**Corrigendum - 6 dated 08/07/2025 to CPC Tender No. BHEL/CPC/SPT/EPC-AHP/26/017**

**Corrigendum - 6 dated 08/07/2025 to CPC Tender No. BHEL/CPC/SPT/EPC-AHP/26/017** for the work of “EPC package for Ash Handling Plant at Singrauli STPP Stage-III (2X800 MW)”.

DRAWING NO.  
PE-DG-520-603-C003  
SHEET 1 OF 1  
REV. 00

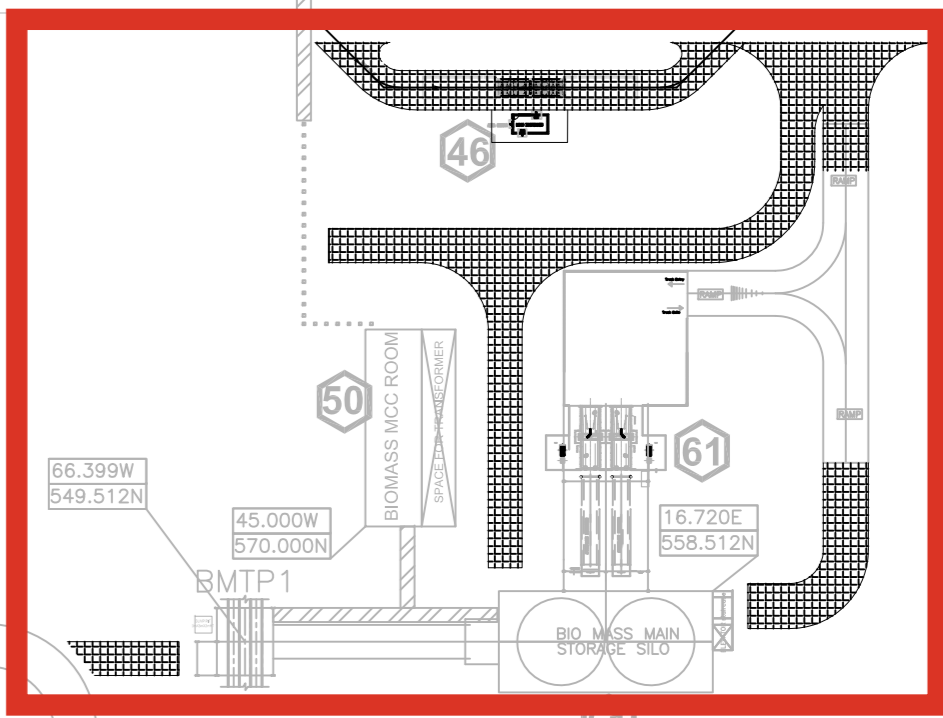
101	PE-DG-520-603-C003	Layouts of Road	As per the Layout of roads, various approach road are marked for various facilities like AHP, CHP, GHP area. Please confirm all the approach roads marked in the layout are in AHP vendor scope.	<a href="#">Road layout drawing PE-DG-520-603-C003 developed from BHEL end is issued along with this corrigendum</a> . Tentative roads for the areas of CHP, AHP, FGD, biomass except Ash silo are marked as guidance. Bidder is expected to develop final layout of roads and

DRG Title: PLANT DRAIN LAYOUT

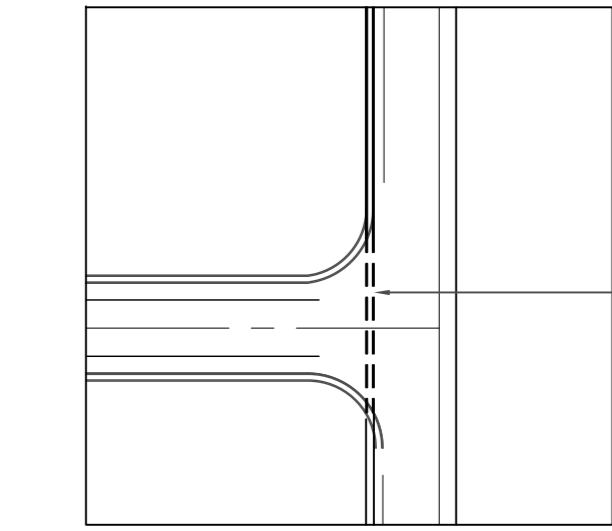
1x800 MW NTPC SIPAT STPP, STAGE-III		
COMPLIANCE RESOLUTION SHEET		
<b>Drg./Doc. No.</b>	NTPC Drg No. 8003-001-301-POC-C-111&8003-001-301-PVC-C-0157 / BHEL Drg. No. PE-DG-520-603-C005 & C006, Rev 0 NTPC Doc No.8003-001-301-PVC-U-0039_0 / BHEL Doc. No. PE-DC-520-603-C003,Rev 0	
<b>Drg./Doc. No.</b>	PLANT DRAIN & SECTIONS	
<b>Transmittal No.</b>	CC-ENGG-8003-001-315-PVC-C-0021/CC-ENGG-8003-001-315-PVC-C-0023/CC-ENGG-8003-001-315-PVC-U-0039, dated 19.11.2024	
S.NO.	NTPC COMMENTS	BHEL REPLY
1	COMMENTS ON DESIGN OF DRAIN, PLOT PLAN & LAYOUT OF ROAD MAY PLEASE BE INCORPORATED.	NOTED
2	CONNECTION DETAILS OF PROPOSED DRAIN TO EXISTING DRAIN TO BE PROVIDED.	NOTED & INCORPORATED
3	DRAINAGE ARRANGEMENT FOR LAYDOWN AREA NEAR SWITCHYARD TO BE PROVIDED.	Drainage arrangement has been provided as per the drain layout in contract stage.
4	Culvert to be mandatorily provided at crossings wherever vehicular /material movement is envisaged	NOTED & REVISED. BOX CULVERTS HAVE BEEN ADDED.

5	STARTING & END POINT OF EACH DRAIN TO BE DEMARCATED ON DRAWING.	NOTED & INCORPORATED
6	CULVERT FOR CROSSING THE ROAD BY DRAIN TO BE DEMARCATED.	NOTED & INCORPORATED
7	DESIGN OF D1A, D14A & D14B TO BE PROVIDED.	All drains have been designed considering the full catchment area of the Contract Stage-III layout. The addition of tertiary drain from building/structure/system shall be directly connected to nearby primary/secondary drain with nominal size & shall be covered in the respective grade slab of the buildings.
8	DRAIN NO. D18A, D12B & D30A ARE NOT MARKED IN DRAIN LAYOUT & REQUESTED TO REVIEW THE SAME.	Noted & Revised.
9	ANY CABLE CROSSINGS THROUGH DRAIN ARE TO BE DEMARCATED	The Cable crossing details shall be covered in Plants Roads drg-8003-001-POC-C-107
10	Suitable drain network has been provided and shall be kept functional during full construction phase to dispose off accumulated water during rains and prevent accumulation of water and flood in the plant area ,	NOTED.

11	Suitable arrangements have been made so that that effluents (plant water) and storm water do not get mixed.	NOTED.
12	Clear water shall be routed to CW channel and contaminated water diverted to Area Pit (s) / Sump(s).	NOTED.
13	Culverts/local humps or bridges, for routing ash pipes at crossing for nallah /water body crossing /roads/rail lines etc. have been provided.	NOTED.
14	OUTFALL POINT TO BE PROVIDED AT A SINGLE POINT CROSSING PROPOSED ROAD	Outfall point has been merged at possible junction i.e., at Outfall point-D. But at other junction locations it is not possible to merge the drains at the depth of the drain will be more than the drain at outfall points
15	ROAD & DRAIN TO ROUTED OUTSIDE OF HEAVY VEHICLE SHED.	NOTED & REVISED.
16	CONNECTING ROAD FROM ETP TO MAIN PLANT AREA ALONG WITH DRAIN TO BE PROVIDED.	NOTED & REVISED.
17	OUTFALL OF THIS AREA DRAINAGE TO THE EXISTING DRAIN BEFORE JOINING THE EXISTING ROAD	This area is under the scope of BHEL-ISG. The drain details will be provided in their respective drg. The legend of roads in this area is marked in Roads drg no.8003-001-POC-C-107

S.NO.	NTPC COMMENTS	BHEL REPLY
19	EXISTING DRAIN TO BE CONNECTED ACCORDINGLY DESIGN TO BE REVISED	From design point of view the quantum of water coming from existing unit has not been considered. The provided drain layout is in line with darin layout in the contract stage . If the same drain is essentially to be connected with Stage-III drain, same shall be suitably done at site.
20	Suitable arrangement to be provided for 132kV cable trench cross-over	Culvert of Size 2000(W)x2000(D) has been additionally provided to facilitate any cable/ pipe crossing purpose.
21	DRAIN NO. TO BE DEMARCATED	NOTED & REVISED.
22	CONNECTING ROAD FROM ETP TO MAIN PLANT AREA ALONG WITH DRAIN TO BE PROVIDED.	NOTED & REVISED.
23	Site levelling & Grading may please be submitted.	NOTED. THE SAME HAS BEEN UPDATED.
24	Surcharge to be revised to 20KN/m2	NOTED & REVISED.
25	COLUMN FOR DRAIN TYPE TO BE SHOWN.	NOTED & REVISED.
26	INVERT LEVEL OF EXISTING DRAIN TO BE VERIFIED PRIOR TO FINALISATION OF INVERT LEVEL OF PROPOSED DRAIN.	NOTED. THE SAME HAS BEEN RECHECKED AND FOUND IN ORDER. THE TABLE FOR DRAIN HAS BEEN UPDATED ACCORDINGLY.

27	BHEL REQUESTED TO REVISED IN LINE WITH COMMENTS ON DESIGN DOCUMENTS.	NOTED & REVISED ACCORDINGLY
28	TOP REINFORCEMENT TO BE SHOWN	NOTED & REVISED.
29	SIZE & THICKNESS FOR CATCH PIT TO BE PROVIDED.	NOTED & REVISED.
30	WEEP HOLE ON BOTH SIDE OF DRAIN TO BE PROVIDED FOR ALL DRAIN.	NOTED & REVISED.
31	DRAIN DETAILS FOR MAIN PLANT AREA HAVING ONE SIDE WITH RCC PAVING TO BE PROVIDED.	Typical Cross section of the drain around BTG is available in Road Cross section detail drg no. 8001-001-301-PVC-C-0037

1. Draining to be made legible, Drains should be more prominently visible and other facilities should be lightened.
2. Drain Width, Slope is to be indicated in the drawing
3. Drain Bed level is to be indicated in the drawing at all junction and where there is change in drain width
4. Drain tie in points with existing drain to be clearly shown and peak flow to be indicated at tie in points
5. Existing drain bed levels and drain width to be indicated at tie in point
6. Adequacy of existing drain in which tie-in is being taken shall be done to establish that there is no flooding in the concerned area.
